VILLAGE OF MAMARONECK HARBOR COASTAL ZONE MANAGEMENT AGENDA

October 18, 2017 AT 7:30 PM - 169 Mt.Pleasant Avenue, Court Room

3. NEW BUSINESS
 - A. **THE RESIDENCES at LIBRARY LANE 145- 149 LIBRARY LANE PRELIMINARY** - Preliminary Review (Section 9, Block 50, Lot 6A) Discuss site plan application for 145-149 Library Lane to remove the existing building and construct a 9 unit apartment building with parking on the ground level. (C-2 District)

Item Summary: THE RESIDENCES at LIBRARY LANE 145- 149 LIBRARY LANE PRELIMINARY - Preliminary Review (Section 9, Block 50, Lot 6A) Discuss site plan application for 145-149 Library Lane to remove the existing building and construct a 9 unit apartment building with parking on the ground level. (C-2 District)

SHEET:
3 of **7**

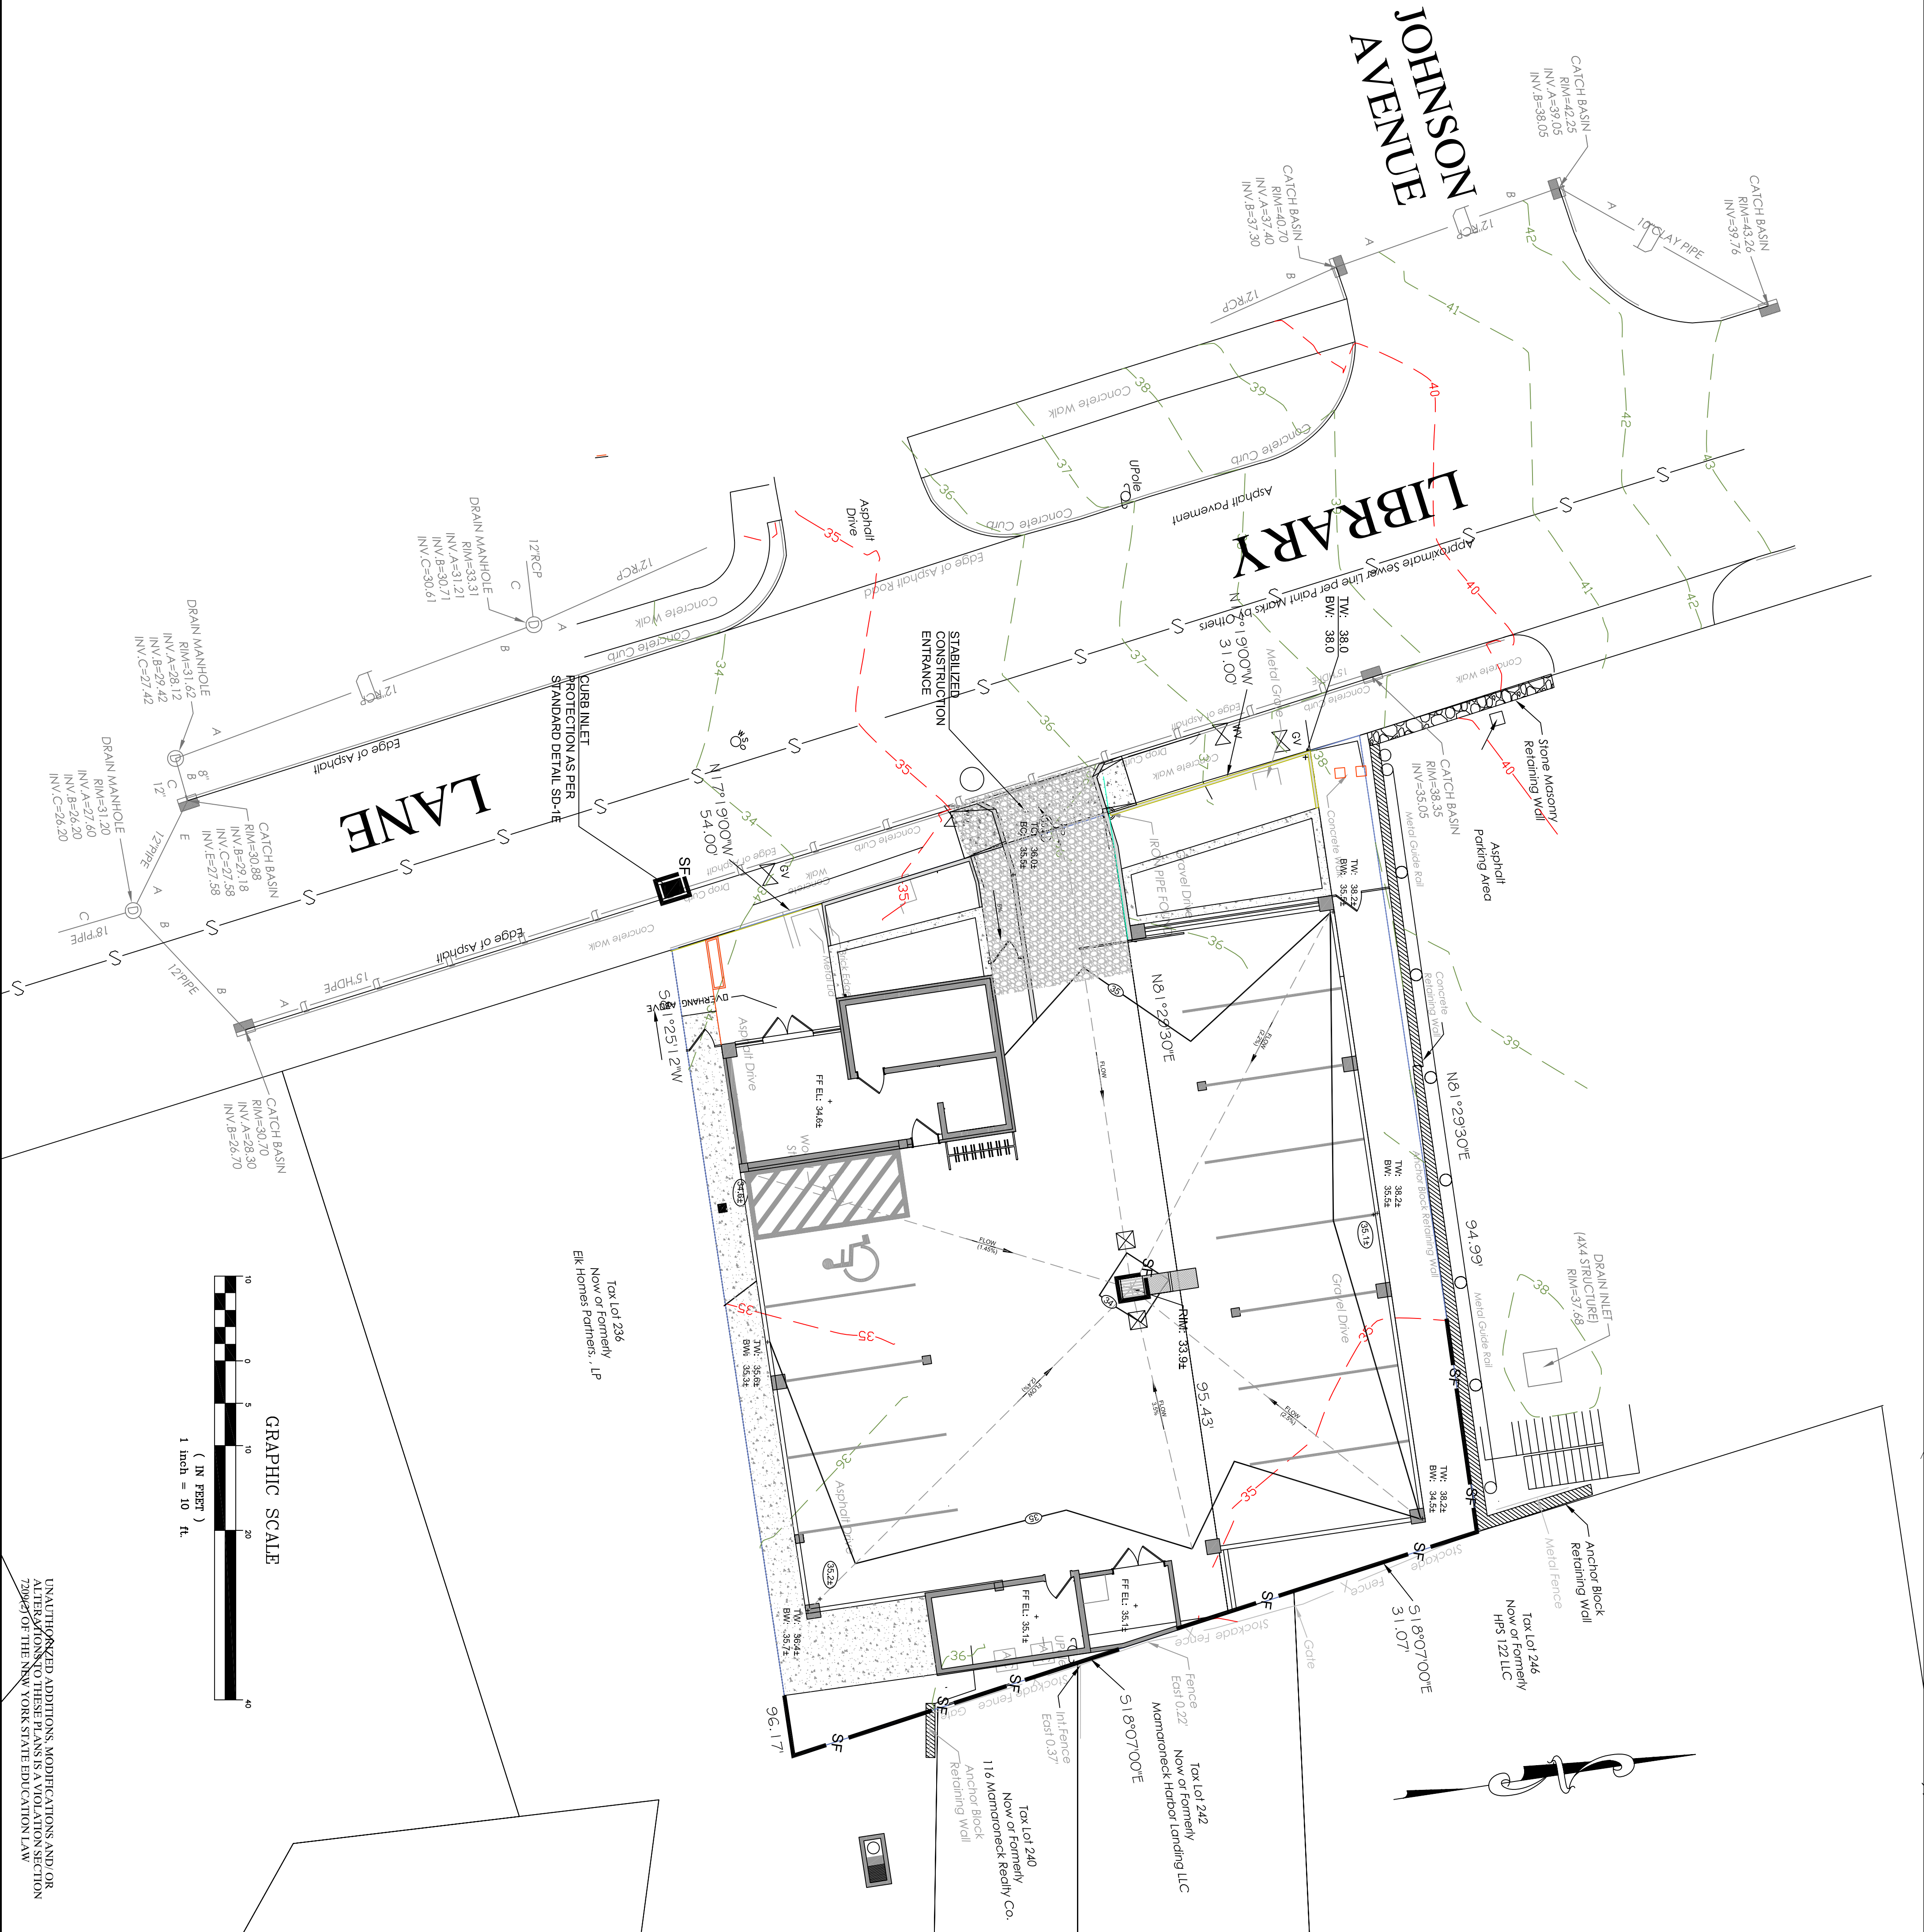
18. The Applicant shall show the location of the inspection port for the proposed 3 cultec infiltrators on the plans. In addition, the Applicant shall provide a detail of the proposed inspection port. **Partially Addressed. The Applicant shall provide a detail of the inspection port called out on Sheet 3.**

SHEET:
4 of 7

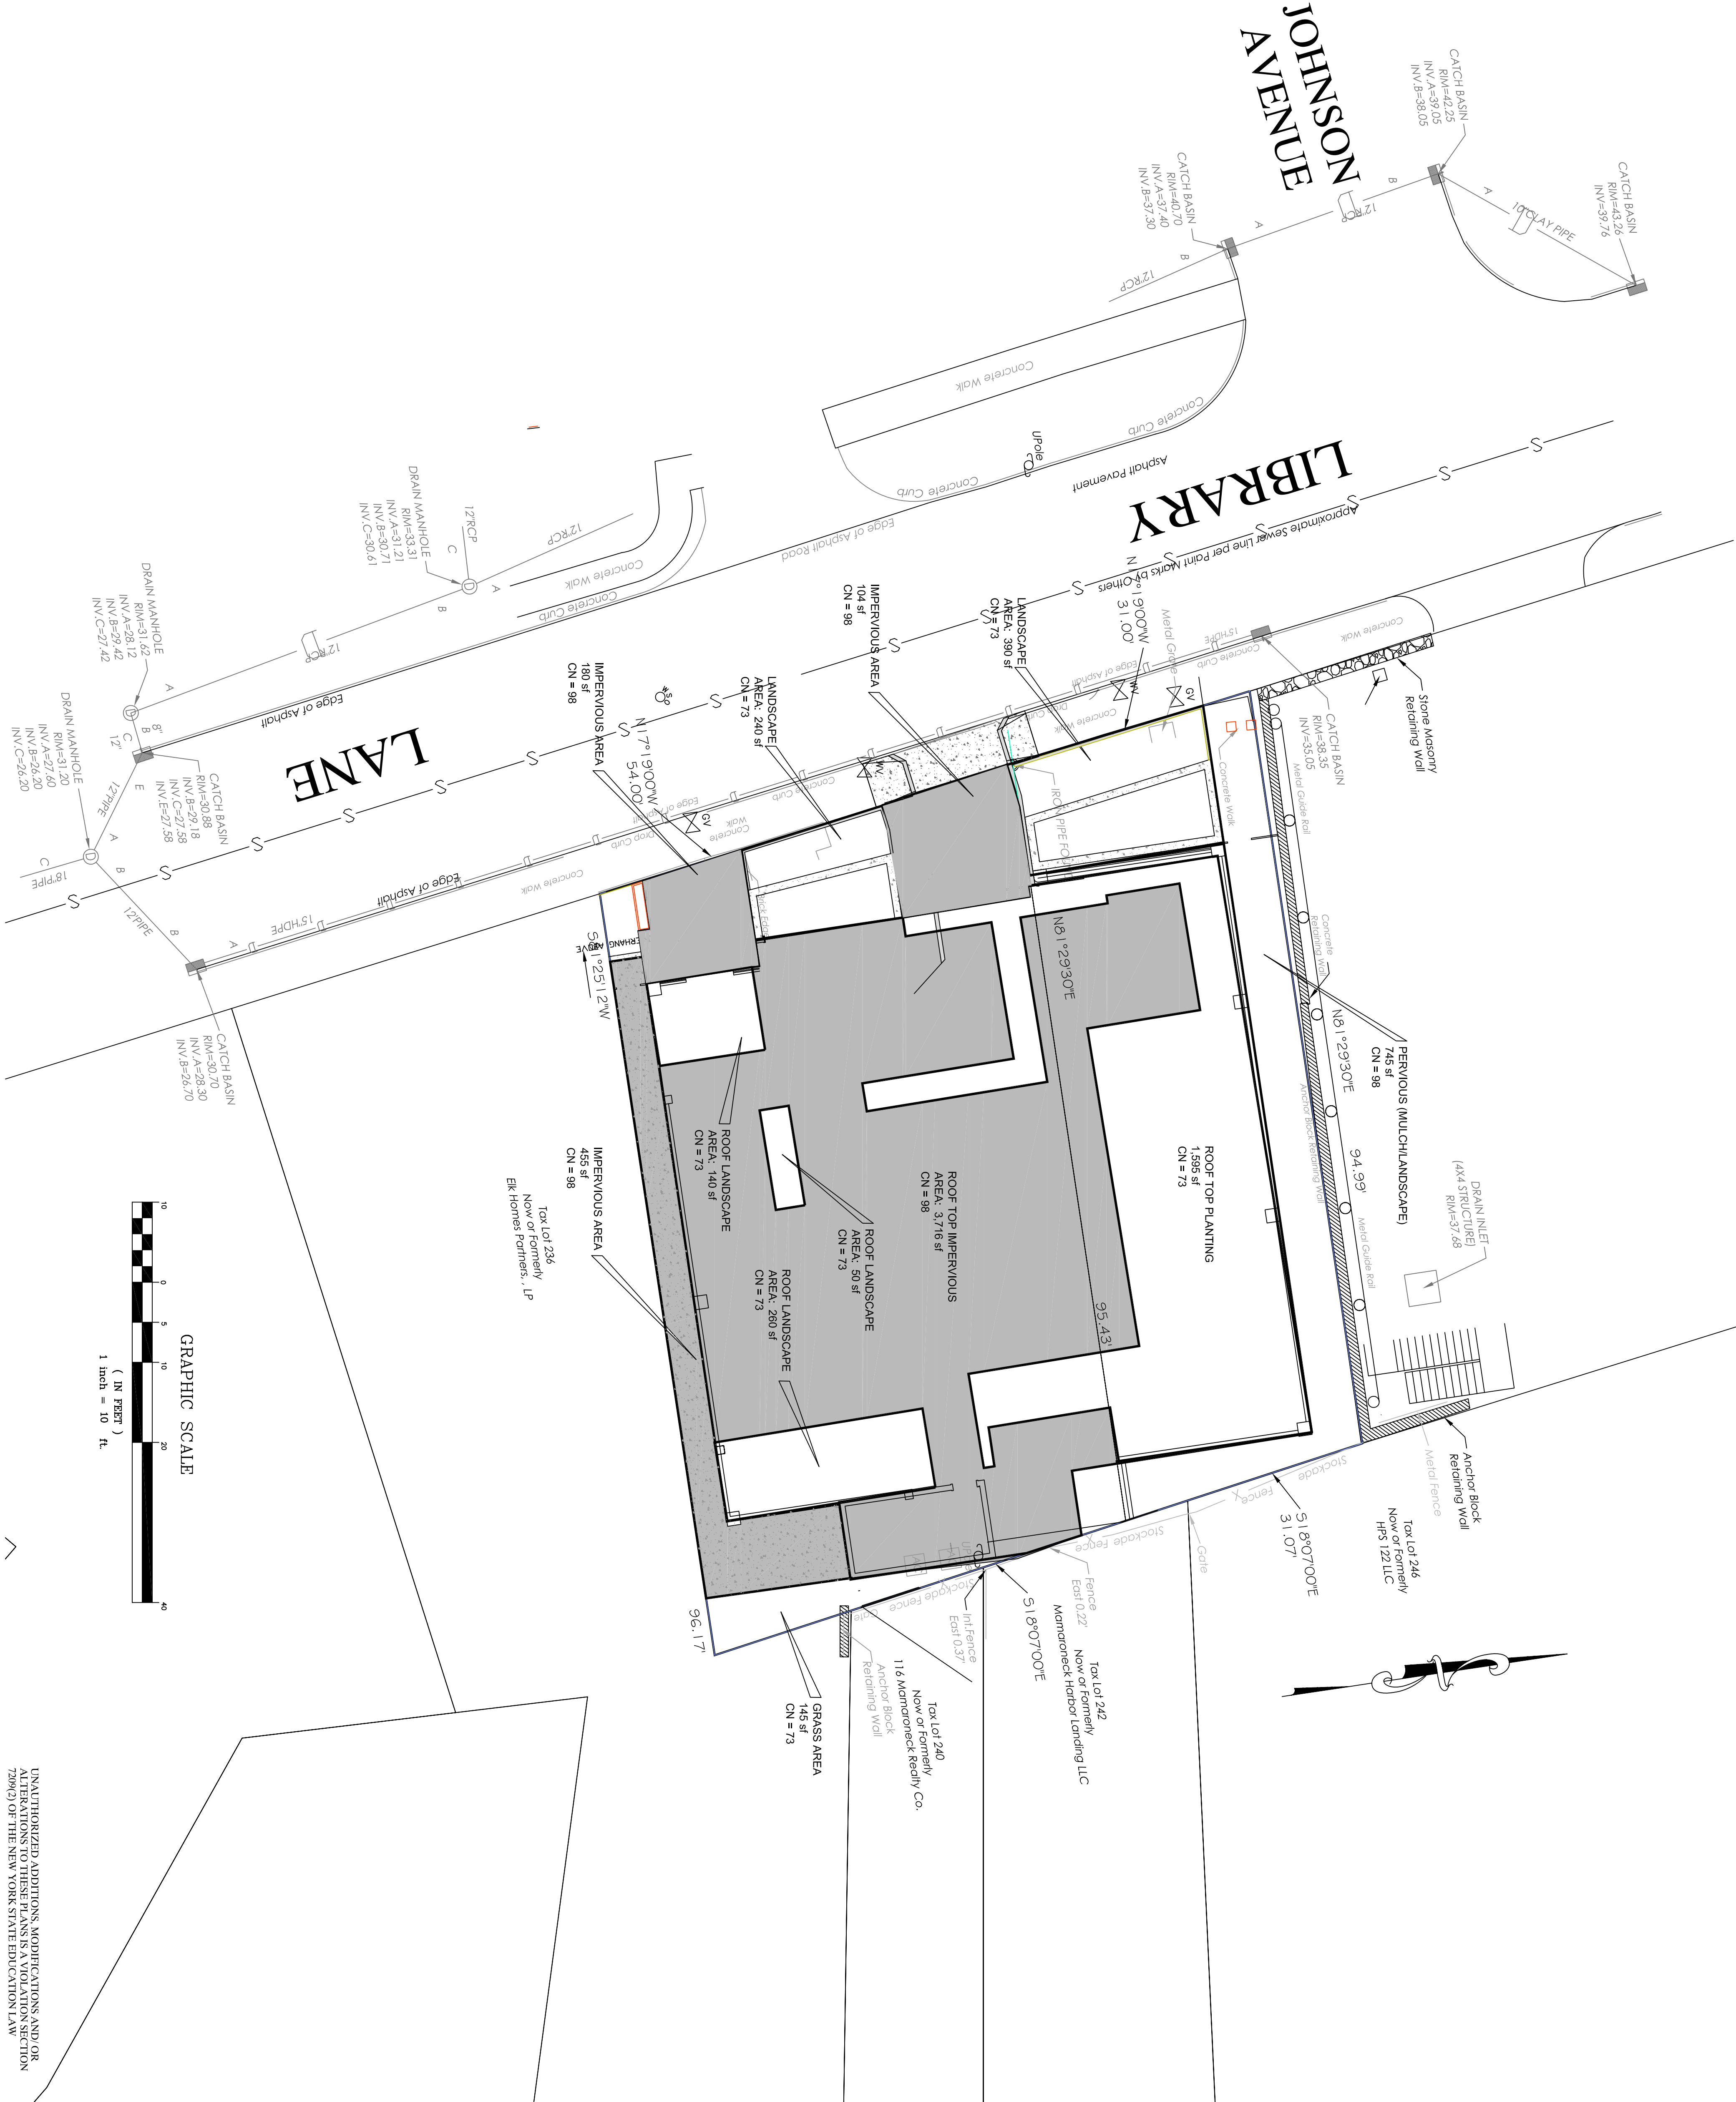
ONE CUL-TEC UNIT (MODEL 330XLHD) HAS THE CAPACITY OF 11.32 cdf. THEREFORE:

552 cdf / 11.32 cdf = 48.7 ft = 7 Units
